# OCEANSIDE UNIFIED SCHOOL DISTRICT DISTRICT SERVICES OFFICE

50% Construction Documents (issued on April 18, 2023)

Review Report –Rev 00 – June 19, 2023

(Documents analysis, coordination, integration and constructability)

First floor – RN (104, 111, 112, 143,144, 145 )  
 Second floor – RN (213, 214,216)

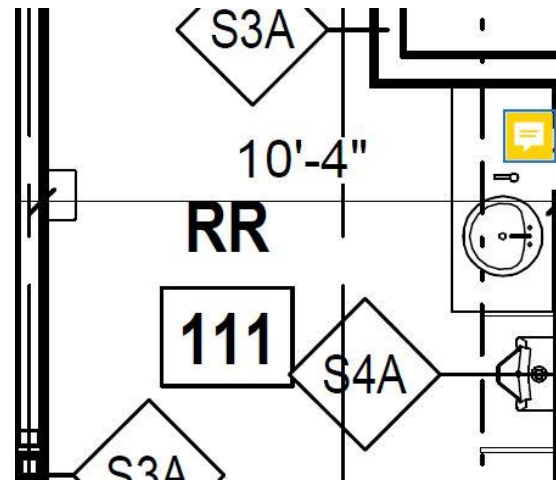
01-Please check if any doors undercut or louver grill for negative pressure spaces.

First floor – RN (111, 143)

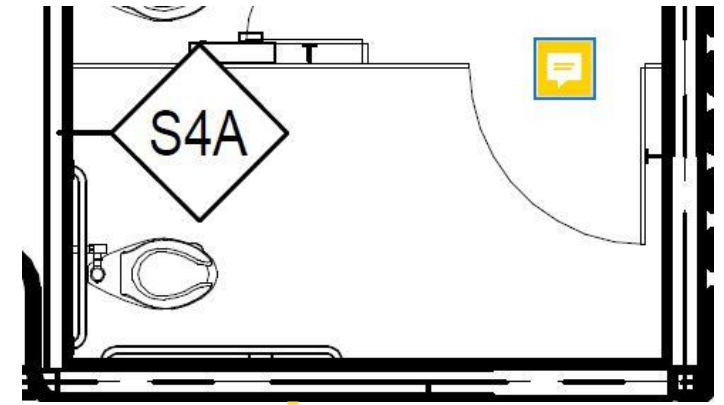
02-In public bathrooms "RR" please clarify if the number of sinks in enough for the floor occupancy

First floor – RN (111, 143)  
 Second floor – RN (213, 214)

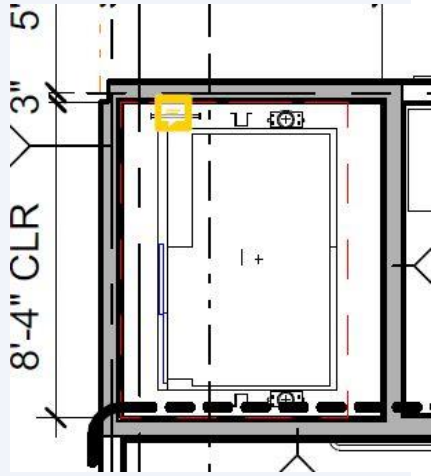
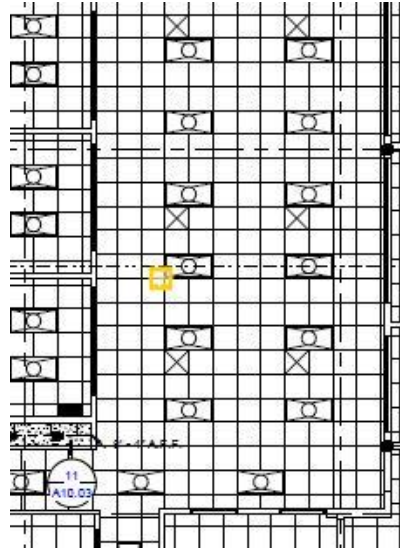
03-In the public bathrooms "RR" handicapped toilet door direction open is inside "check and revise the direction "

Ceiling plan

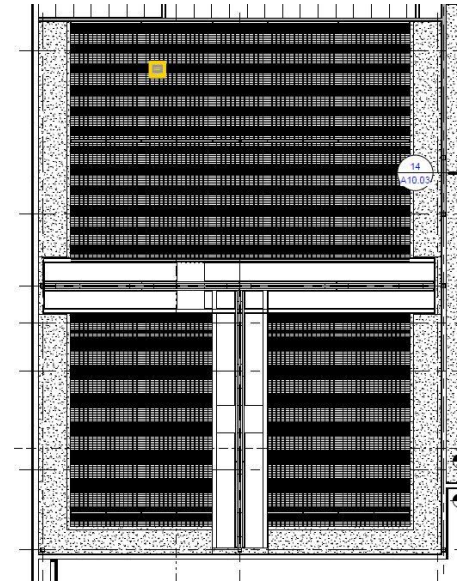
05-Revise and checking for all Returning HVAC systems in ceiling plans

06-Re-check and co-ordinate the maintenance access panels in ceiling plans

Ceiling plan (second floor)

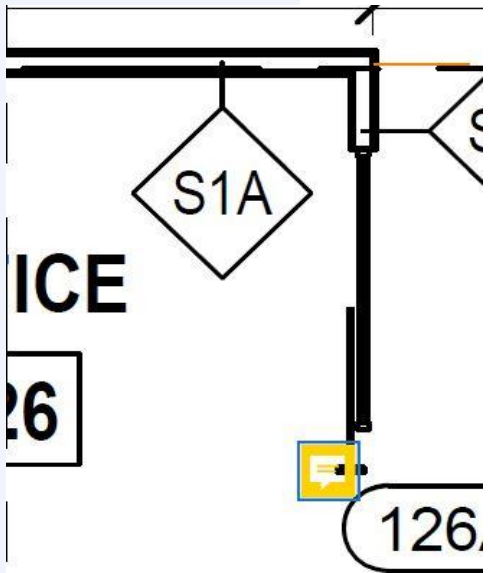
07-There is no lighting fixture shown for the "Board Room" in ceiling plan or even the electrical drawings but there is only LED strip light which is not providing much LUX for the big hall

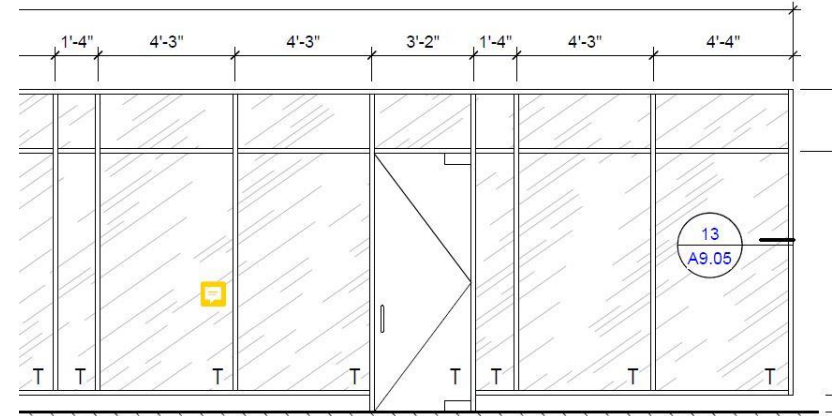
08-There is no description and details for the sliding doors

Door schedule

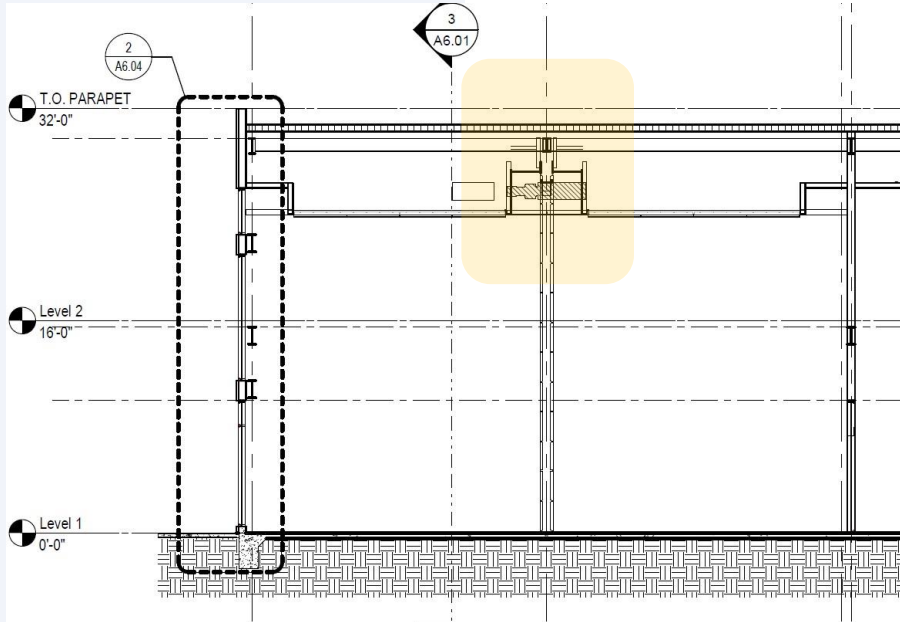
09-There is no description and details for the "FG" door type

10-In storefront glass there is some of the glasses in Timbered and some else in not Timbered please check

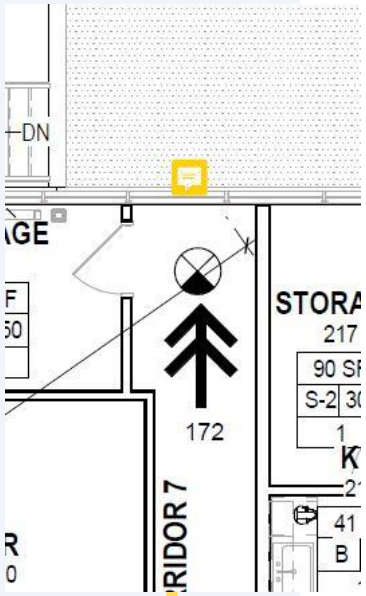
11-The Section Showing the height of the splitter portion

Second floor

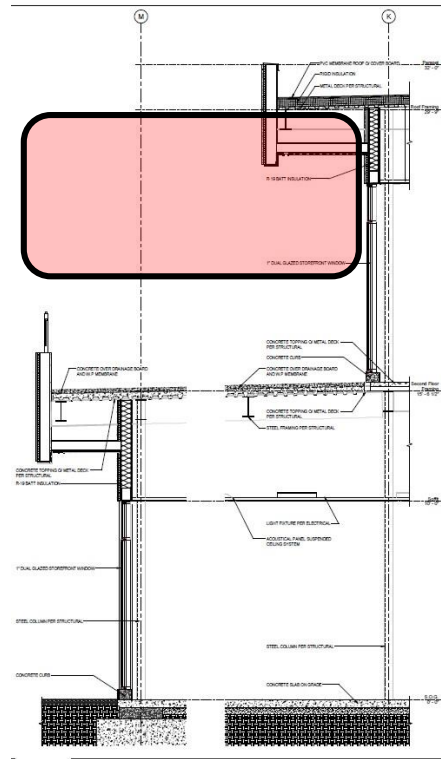
13-In the CODE ANALYSIS drawings that showing the Emergency evacuating strategy, in the second floor between axe 6 & 7 there no door opening for the emergency exit, please check and clarify

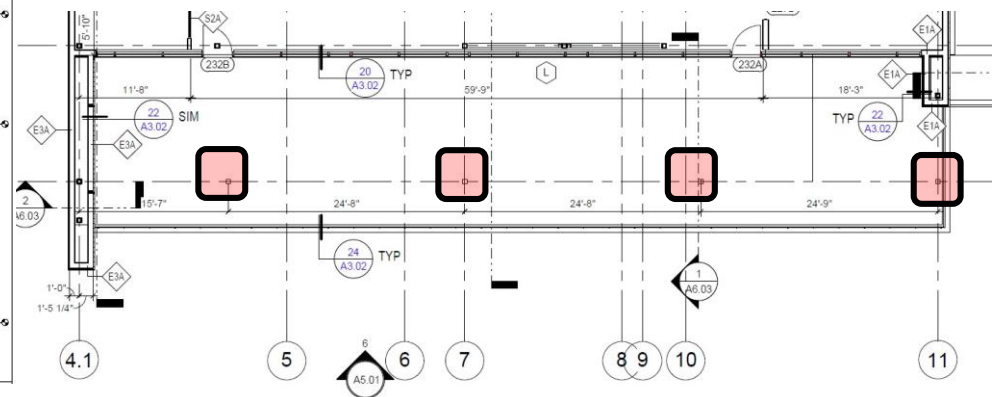
14-The 3D shot showing there is a sunshade above the outdoor terrace in second floor but no details provided or mentioned in architecture drawings

The Section Not showing the tent

In Terrace showing the columns but no shell

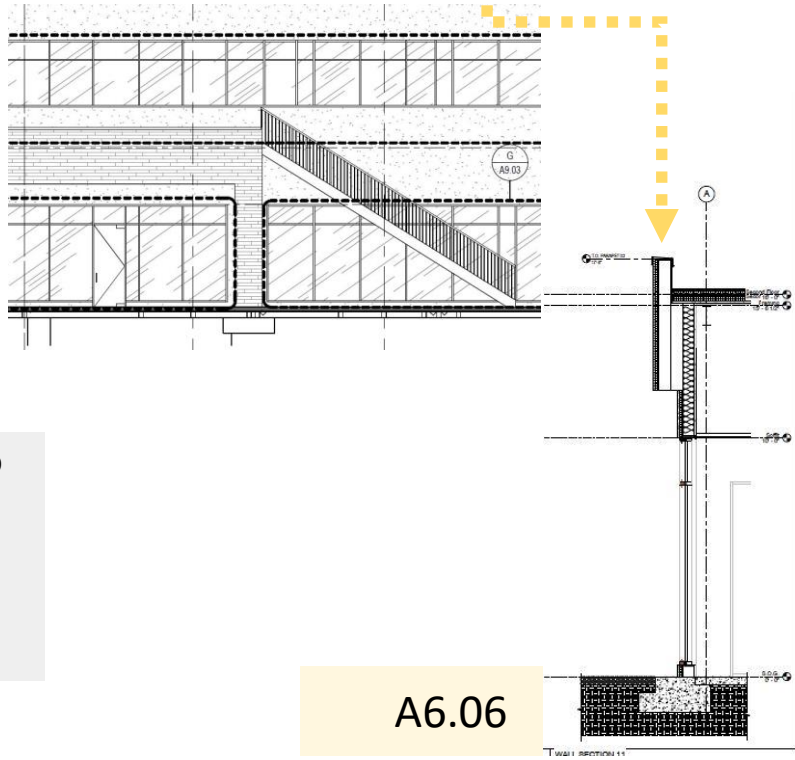
17-at the first floor exterior deck along Axe "A" from Axe 6 to 12 Please consider the parapet height while using this external deck as an emergency evacuation plan

S - 101

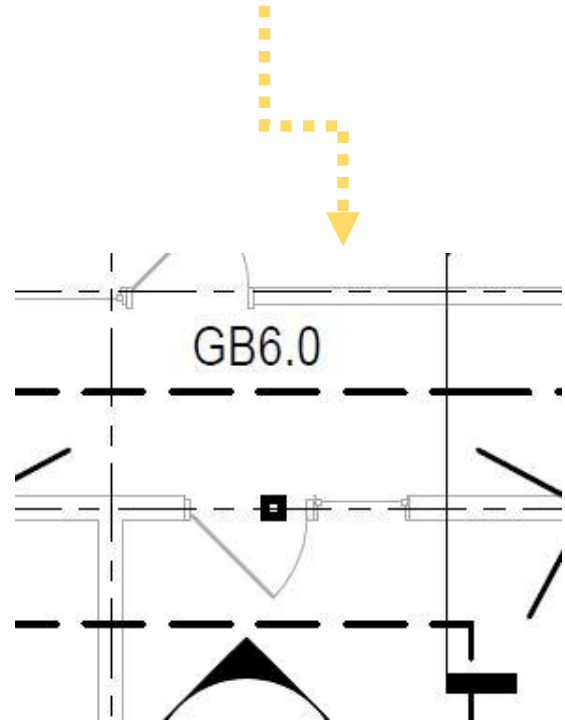
18-Check and relocate column "c1" between axe " D & E " on axe " 12 " if relocate is better for the window.

19-Check the door location and co-ordinate it with the steel bracing along axe "D"

S - 101

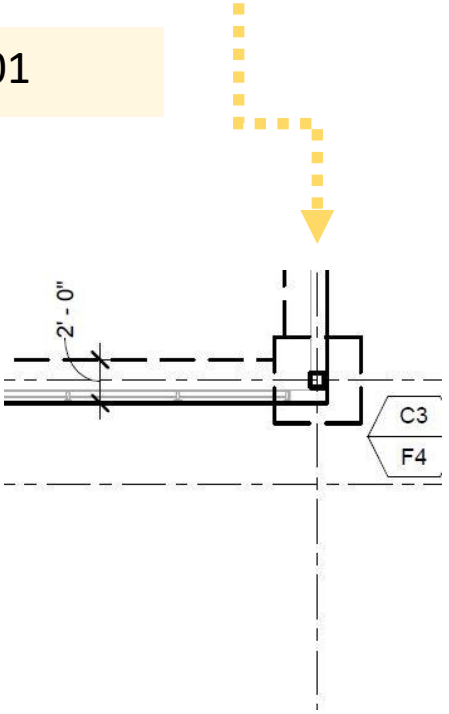
20-For example the structural column along axe " 3.1 " referenced to column schedules the width of columns for "c3" is 8\*8\*0.5 and in Architecture drawing Shows that column is embedded in partition type . " E2A" , that's width in 6" please check the thickness of columns that can't applied inside the wall.

L2.01

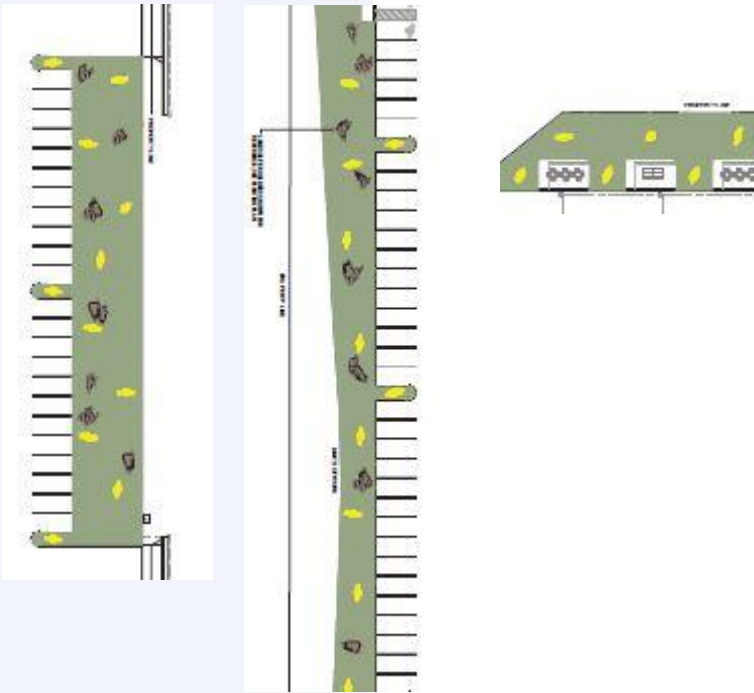
01-There is no piping network for irrigation except at property line

M2.01-M2.02

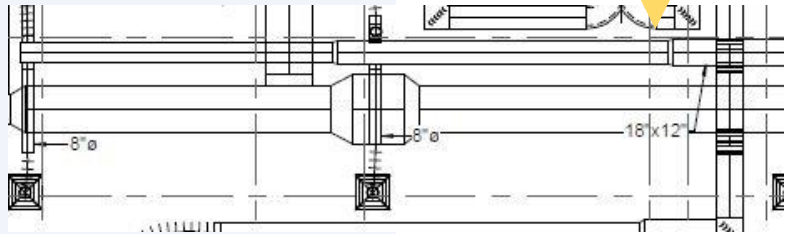
06-Check fire damper used for fresh air ducts in case of fire scenario

M2.01-M2.02

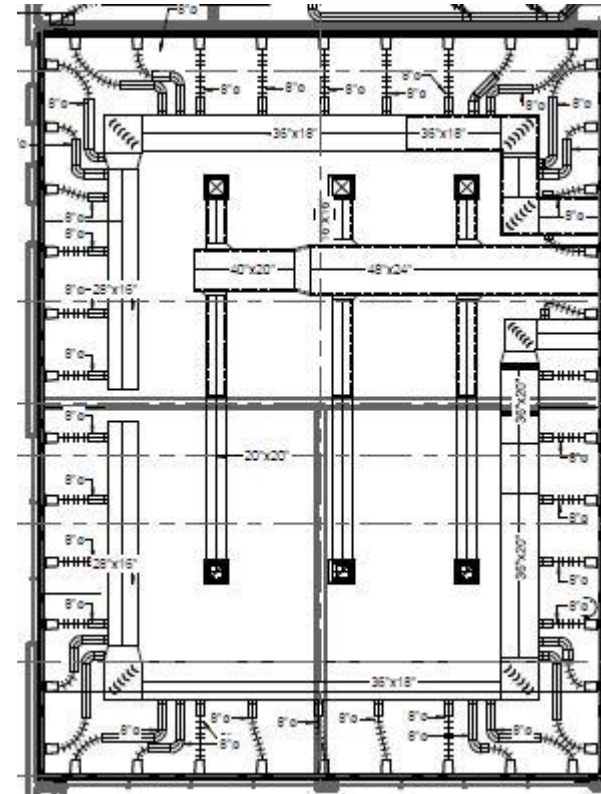
07-Duct work and flexible routing at board room need to be checked and coordinated with architecture

M2.01-M2.02

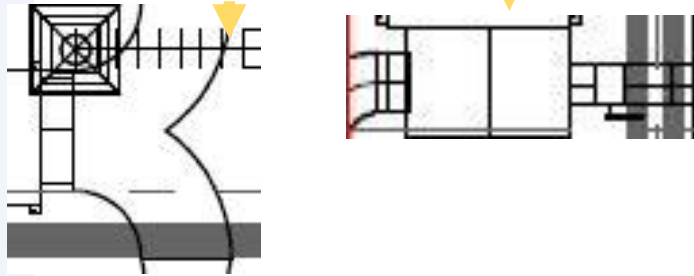
08-Return air plenum box details needed

P2.01

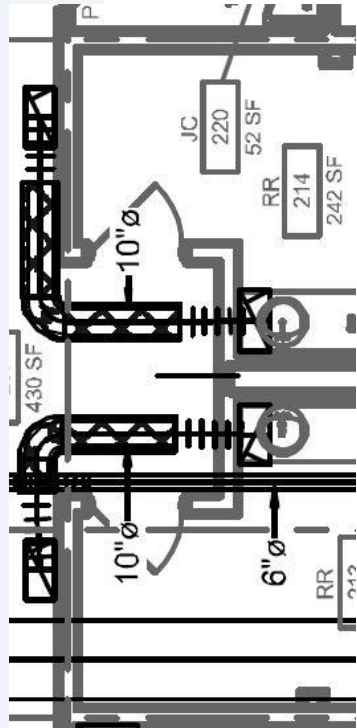
12-Fan coil unit drain detail is missing and some units drain is missing

M2.01-M2.02

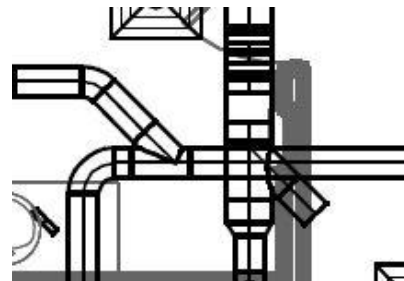
15-Check duct work fabrication specs to compile with SMACNA and other standards

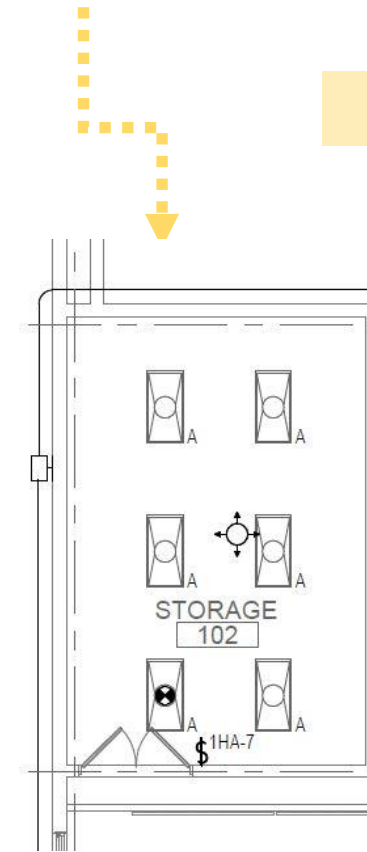
16-Check and coordinate duct sizes and routing considering the braced and x-braced for steel structure.

E3.02

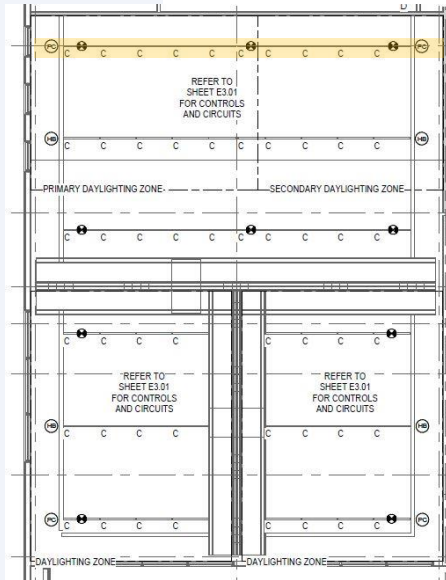
21-LED strip in BOARD ROOM need to be checked for enough lighting

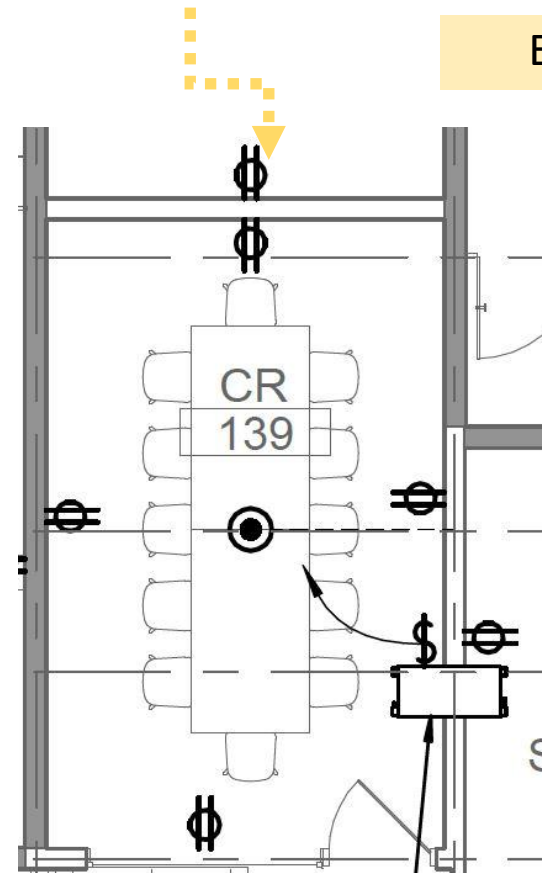
25- missing the location of distribution board panel on the roof

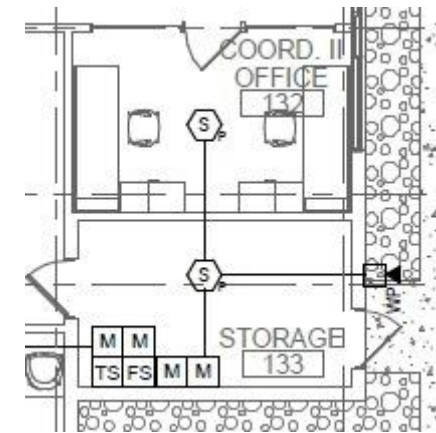
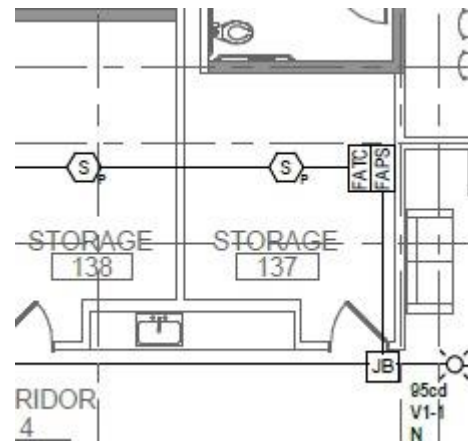
29 -Check Horns/strobes loop to be separated from detectors loop, refer to (FA2.01) Please clarify.

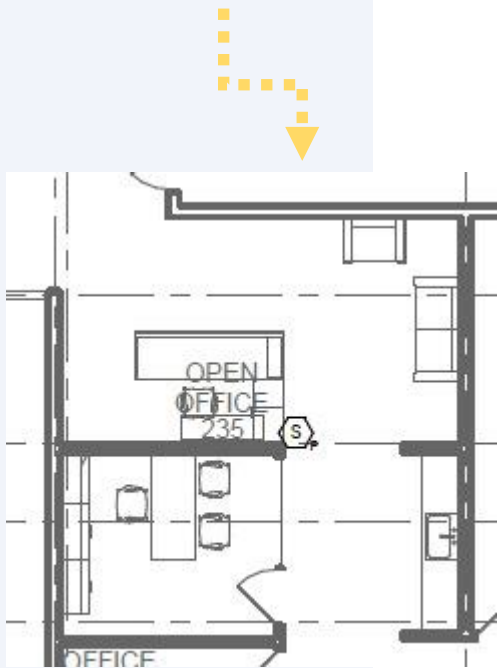
30- Check the 4 monitor modules in storage room, refer to (FA2.02)

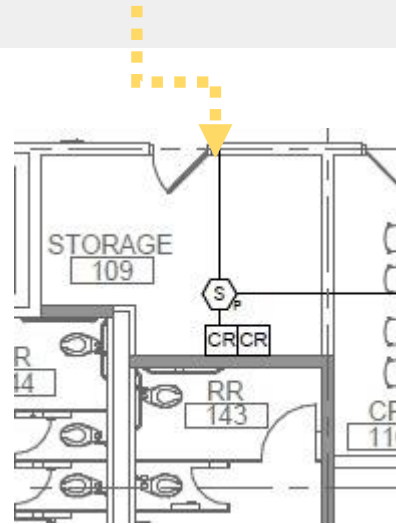
31- Check smoke detector location in offices as possible to avoid dark point.

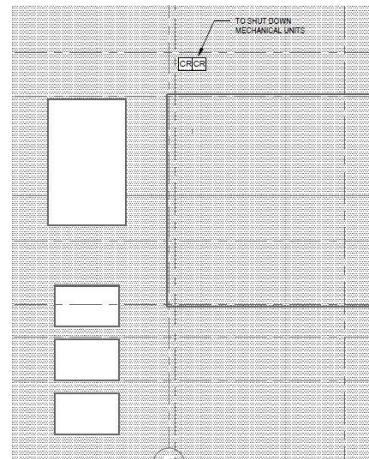
32- Check the two relay modules CR, refer to (FA2.01)
